**Responses to NRC Letter Dated August 19, 1997 and December 5, 1997, Regarding NRC  
Acceptance Review of the Reclamation Plan for the White Mesa Uranium Mill**

**Source Material License SUA-1358  
Docket No. 40-8681**

**Response to Nuclear Regulatory Commission / White Mesa Mill Reclamation Plan  
Comments Dated August 19, 1997  
Source Material License SUA-1358**

**Response to Nuclear Regulatory Commission / White Mesa Mill Reclamation Plan  
Comments Received December 8, 1997  
Source Material License SUA-1358**

## Cell 2 Settlement Monitors

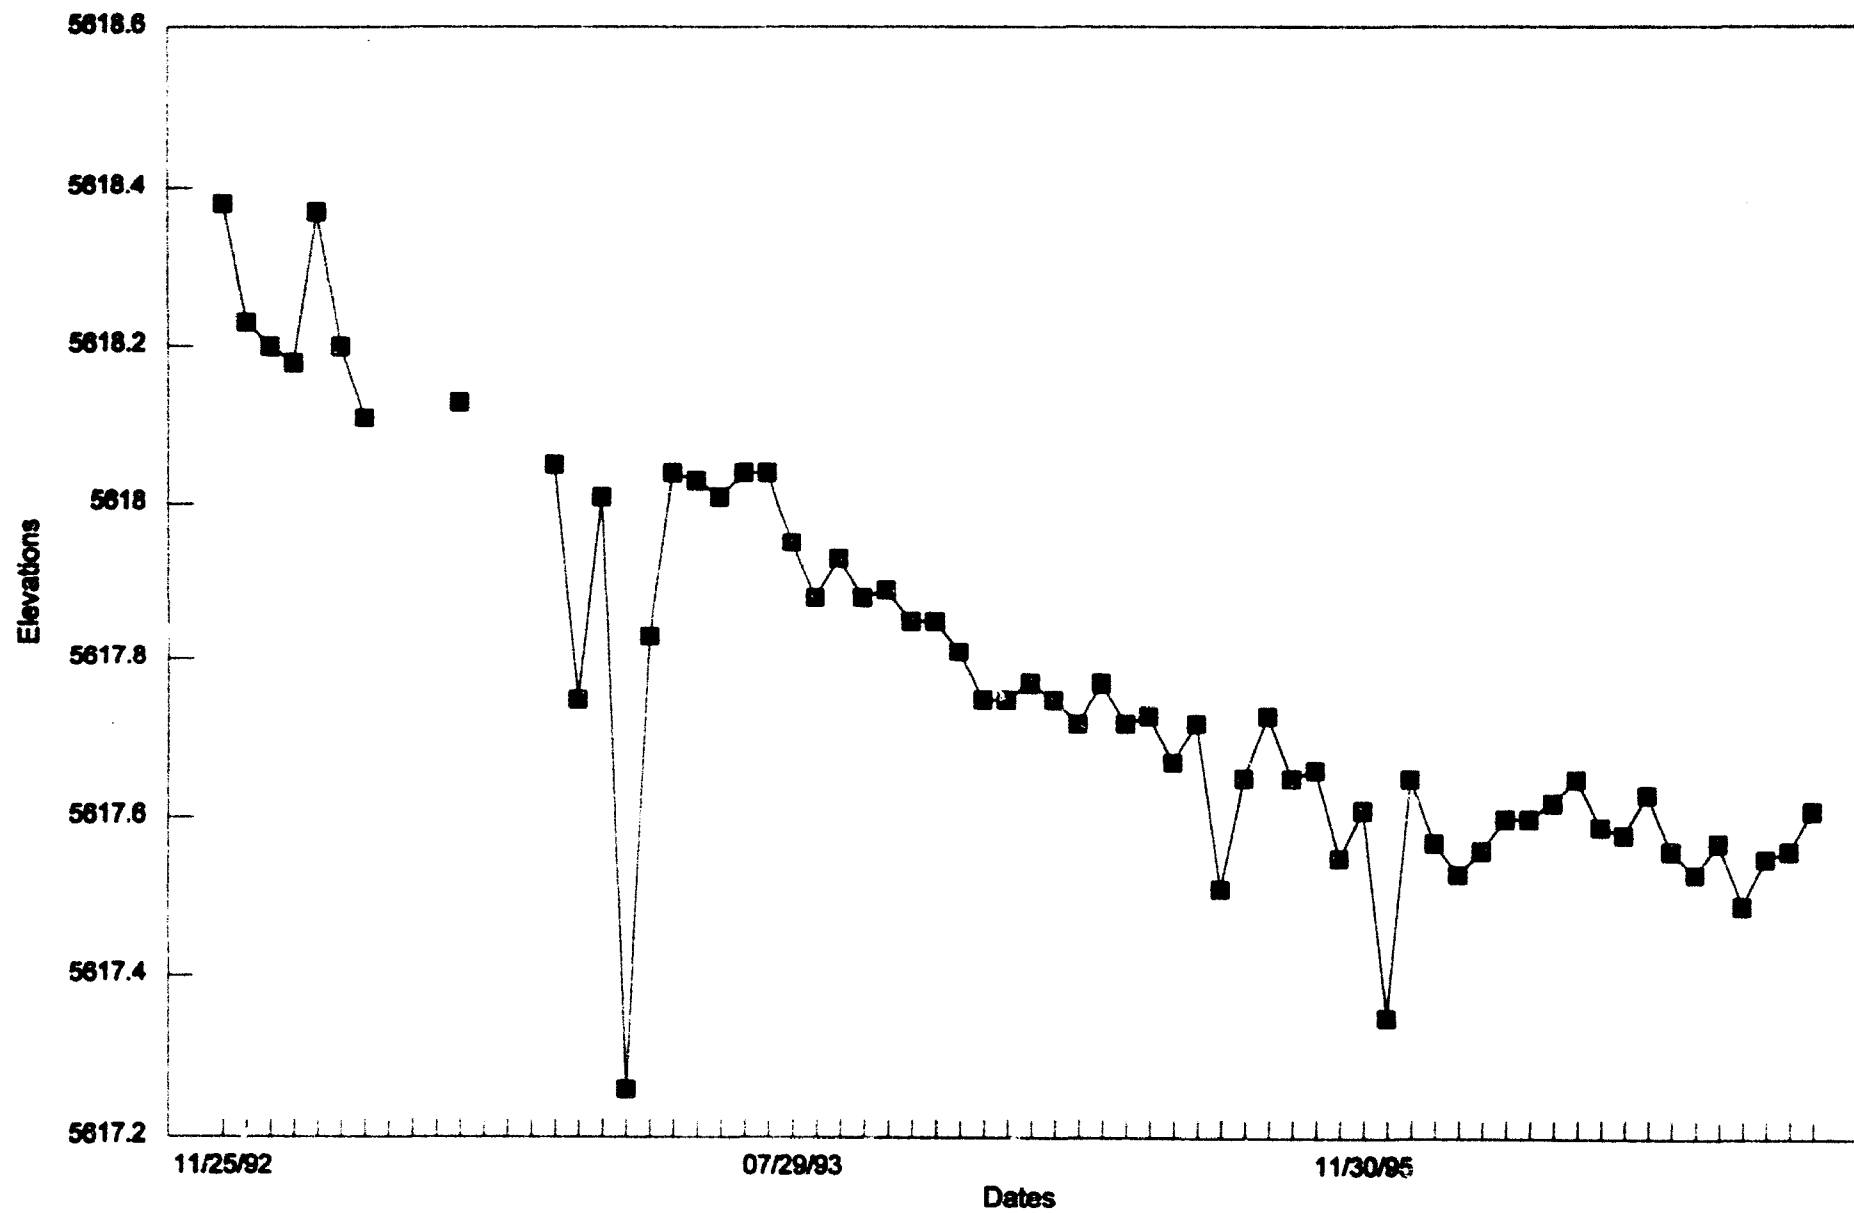
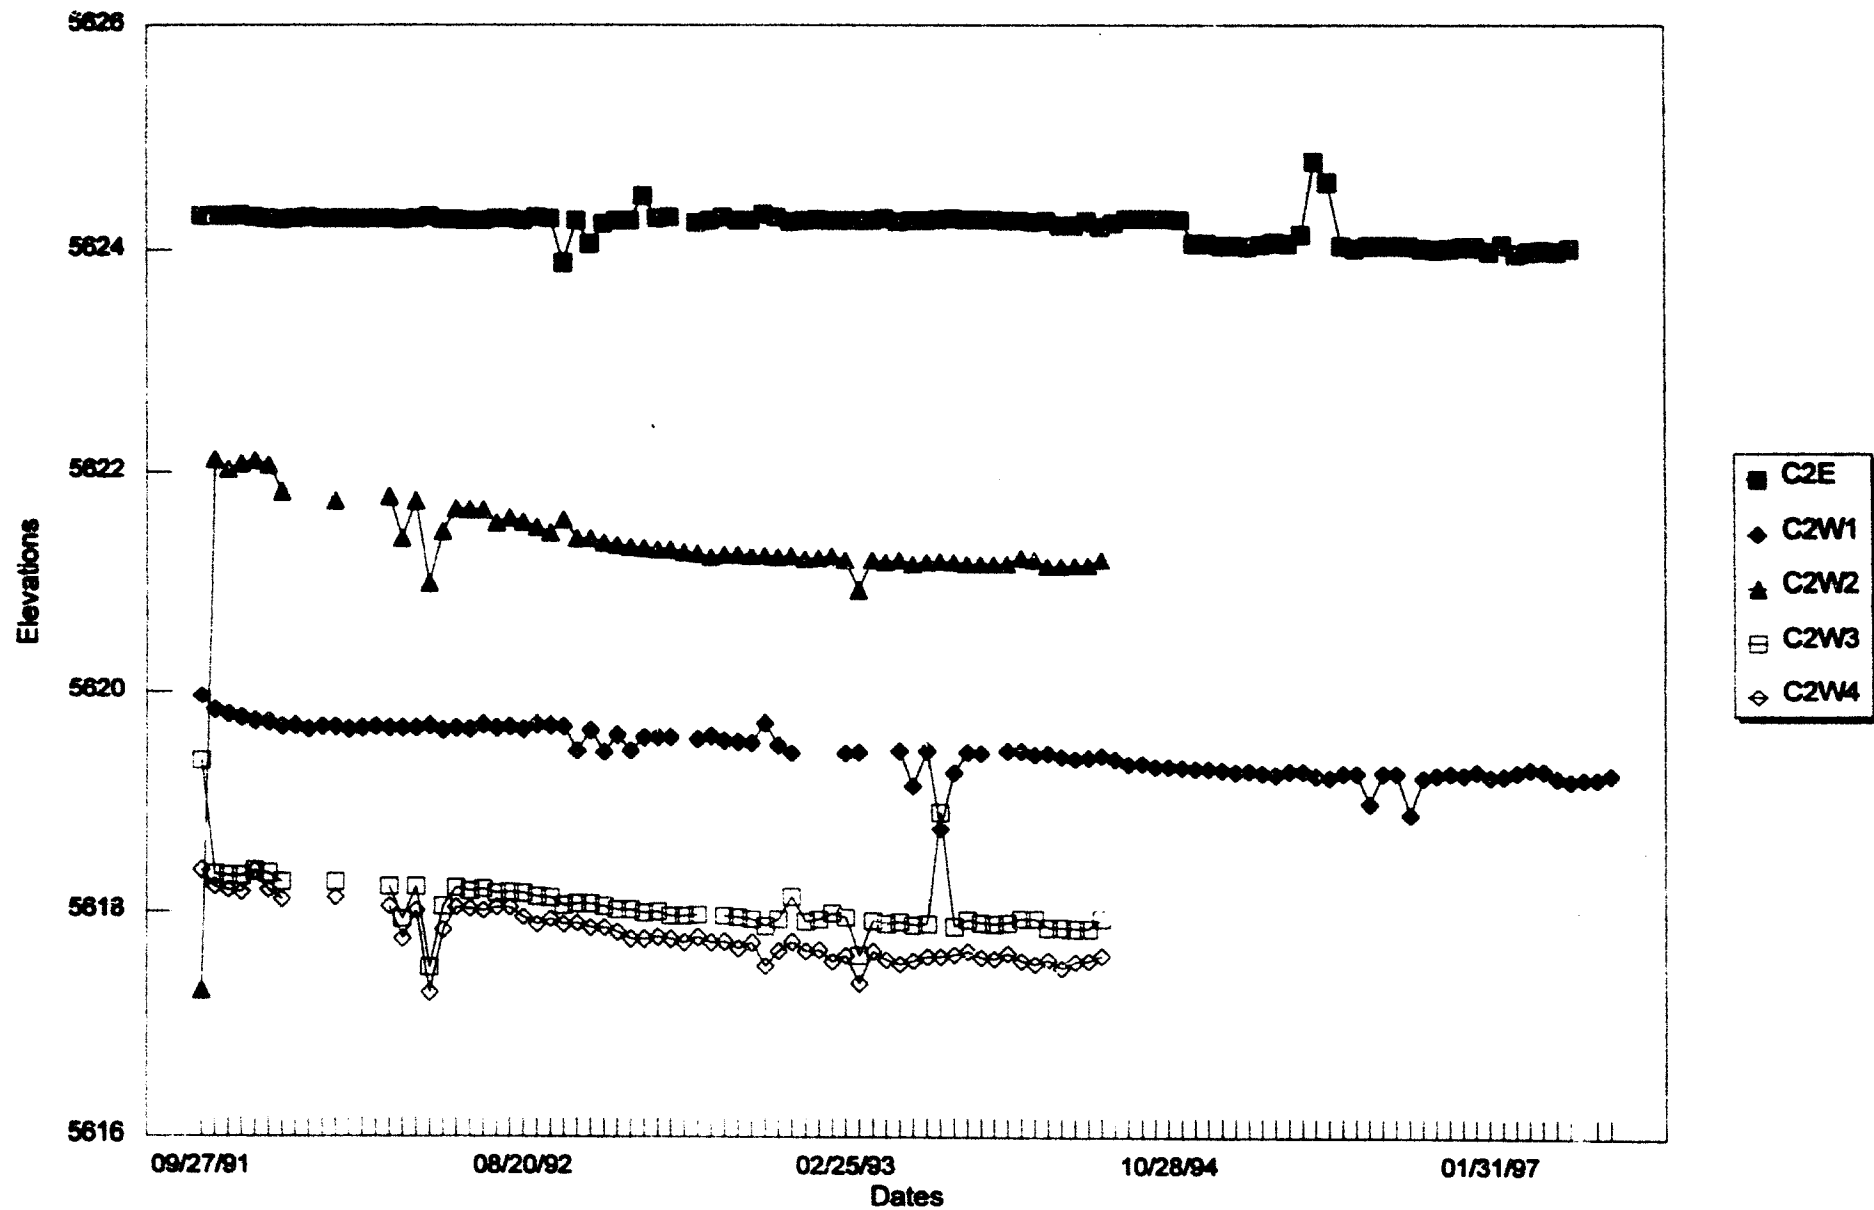
**(2) *An analysis of the total and differential settlements of the tailings surface and the effects of such settlements on soil cover integrity.***

Analysis of the total and differential settlement of the tailings surface was performed using the survey data compiled for the five settlement monuments installed within Cell 2. These monuments were installed on the surface of the tailings, between August 1989 and November 1992, prior to the placement of approximately three to four feet of random fill material. Survey results of each monument were plotted as time vs. settlement graphs and are presented in Attachment 2 of this response.

Review of the survey data and graphs shows that primary consolidation of the tailings has occurred, and the settlement rate has been very slow with minor total values. The maximum total settlement recorded is 0.97 feet, and the differential settlement is on the order of 0.50 feet. Approximately 81 percent of the total measured settlement occurred within the initial three years. Additionally, recent survey data indicates that the settlement has virtually stopped. From September 1995 to September 1997 the settlement averaged less than 0.03 feet per year, which is within the expectable survey error of 0.05 feet. This indicates that the settlement since 1995 is negligible.
